Memorandum

SUBJECT: Circumlunar Missions

DATE: JUN 29 1965

FIGURE 2.1-1

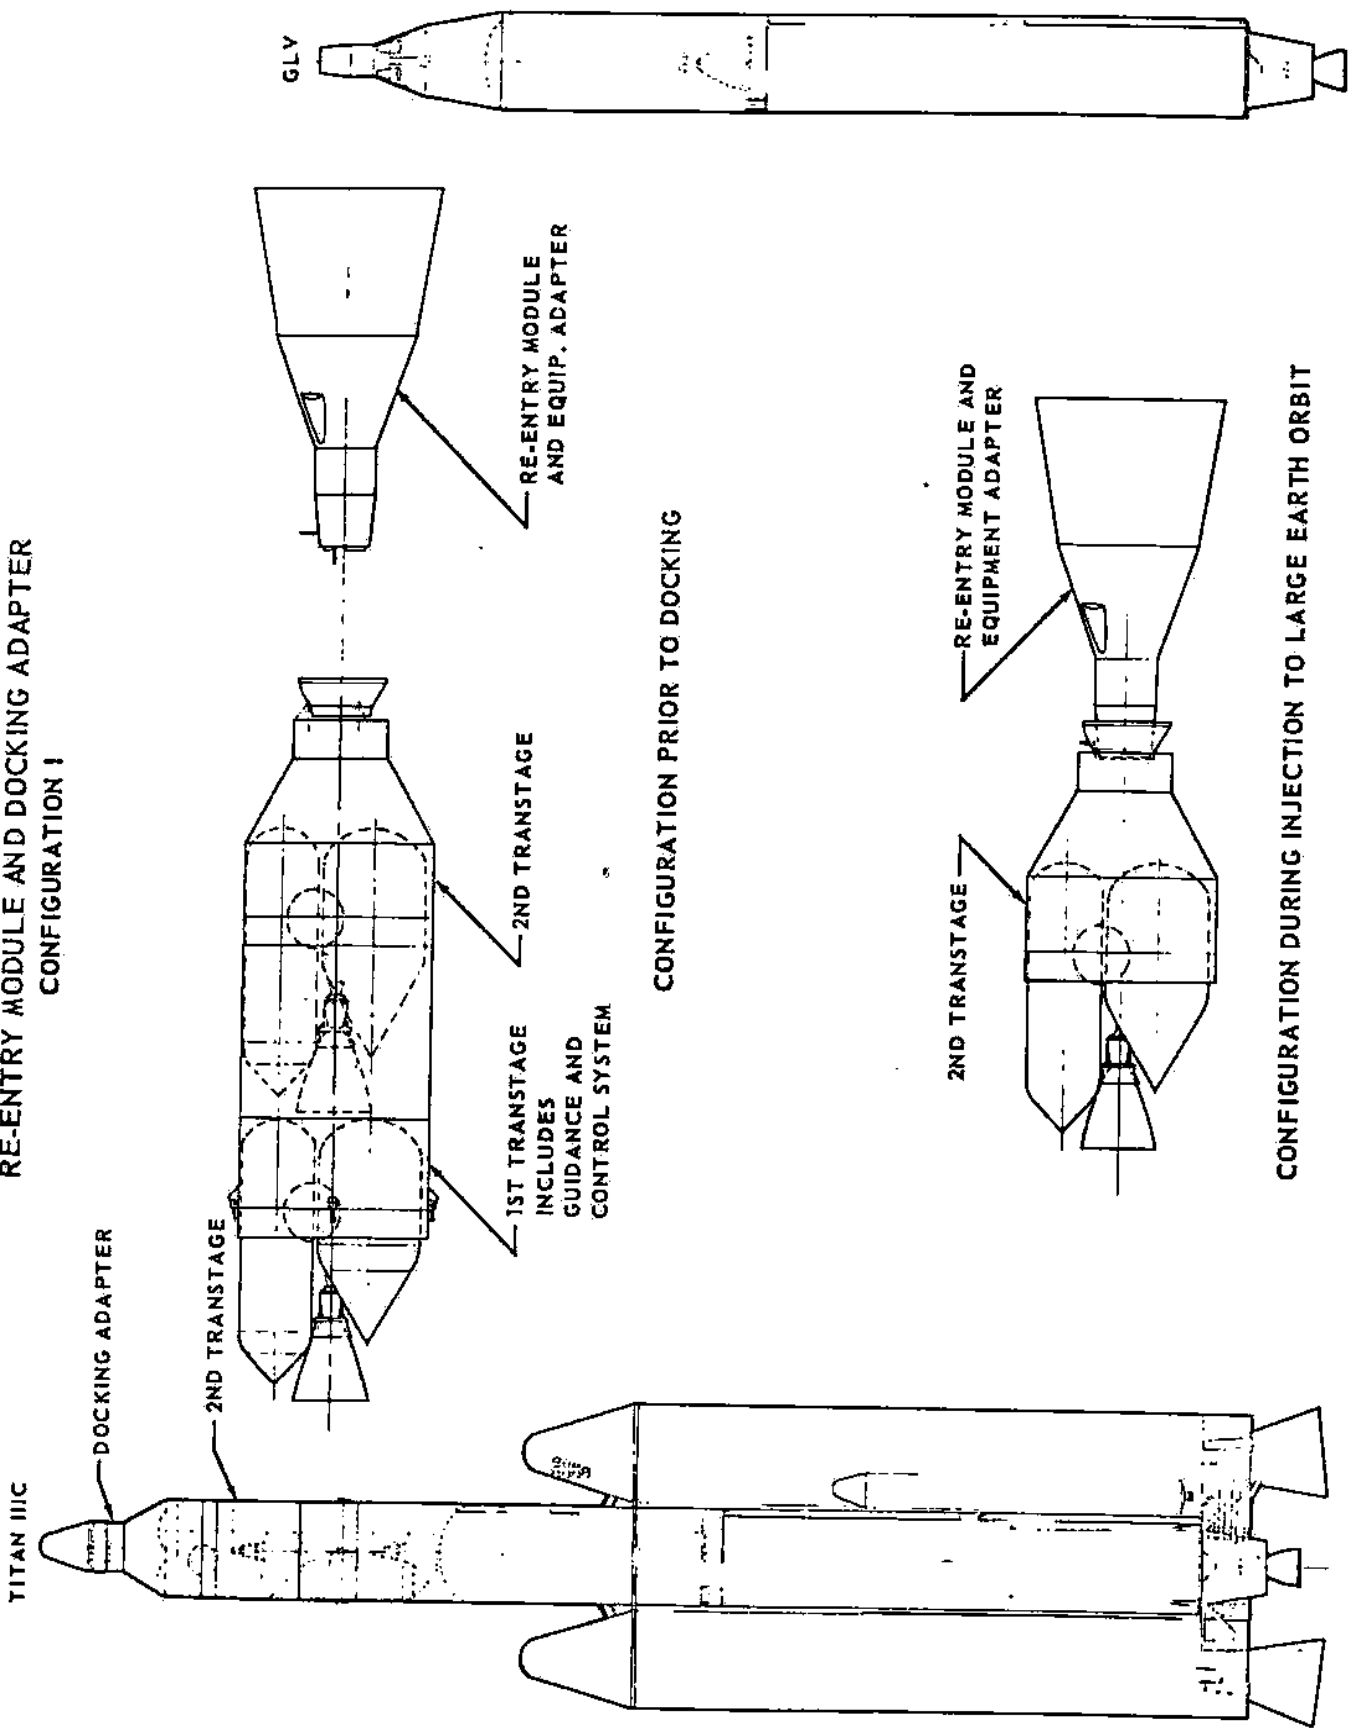
2. In this proposal the Gemini spacecraft modified for circumlunar flight is launched into earth orbit with a GLV. The Titan IIIC launches a stripped down transtage that provides the propulsion for injection to circumlunar velocities after rendezvous with the spacecraft. The general arrangement and flight hardware are summarized in enclosure (1) (Figure 2.1-1 of Attachment C).

3. The principal changes to the Titan IIIC involve using a double transtage. The first provides propulsion during launch to earth orbit and contains the attitude control and an equipment module for use during rendezvous with the spacecraft. A Gemini Target Docking Adapter is mounted on top of the second transtage.

7. No money estimates were presented by Martin or MAC; however, some preliminary estimates by GPO indicated \$350M.
8. I think the proposal is feasible, but not within the time and effort indicated. The equipment and mission are too marginal to absorb changes and additions that will be required without extensive redesign and testing.

RELATED SCHEDULES

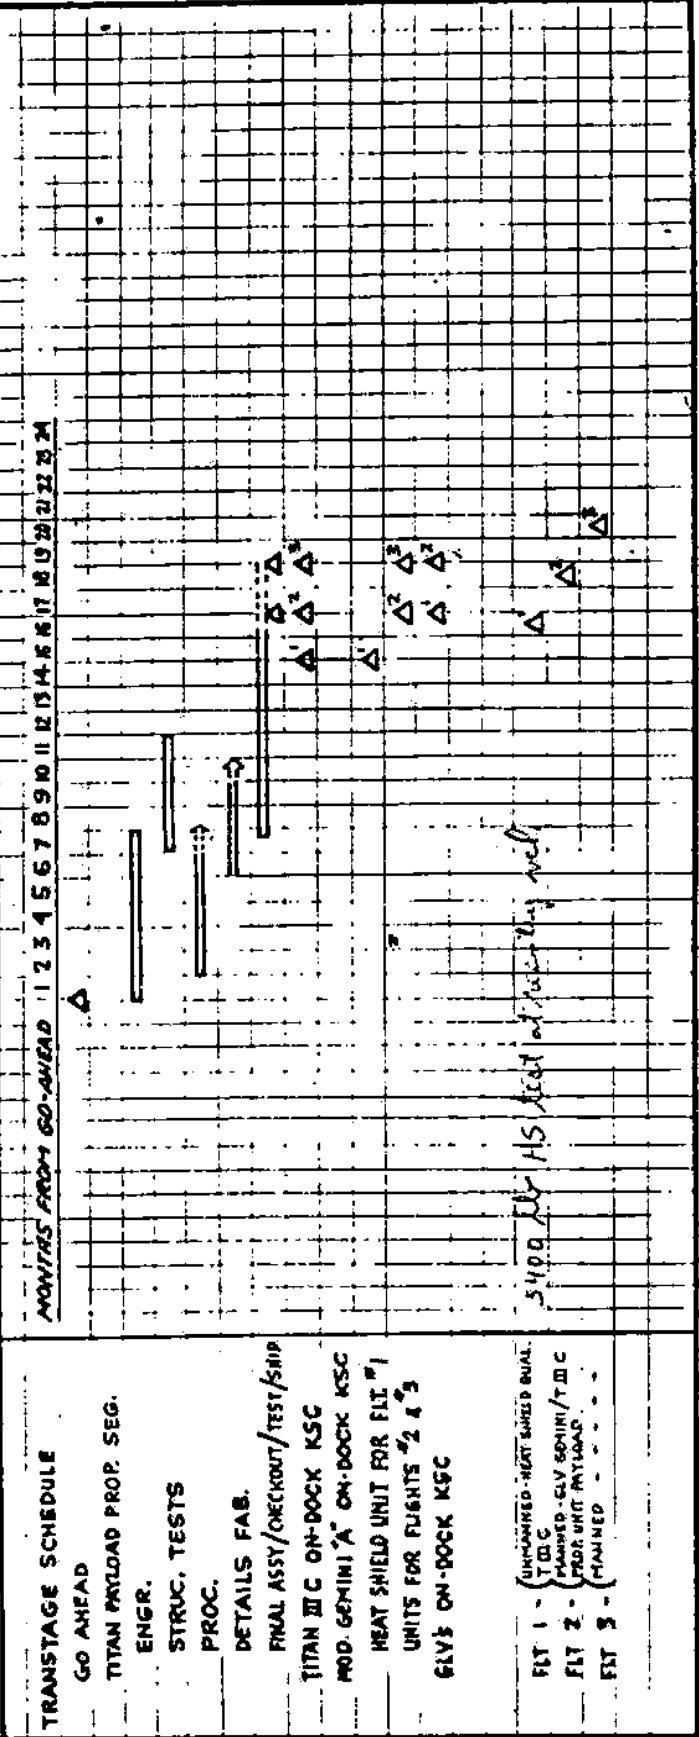
- c. Manned Circumlunar Orbit.
6. The Martin schedule, enclosure (4) (last page of Attachment A), indicates completion by April 1967. The MAC schedule (not available) is even earlier using two refurbished spacecraft and a go-ahead by July 1.
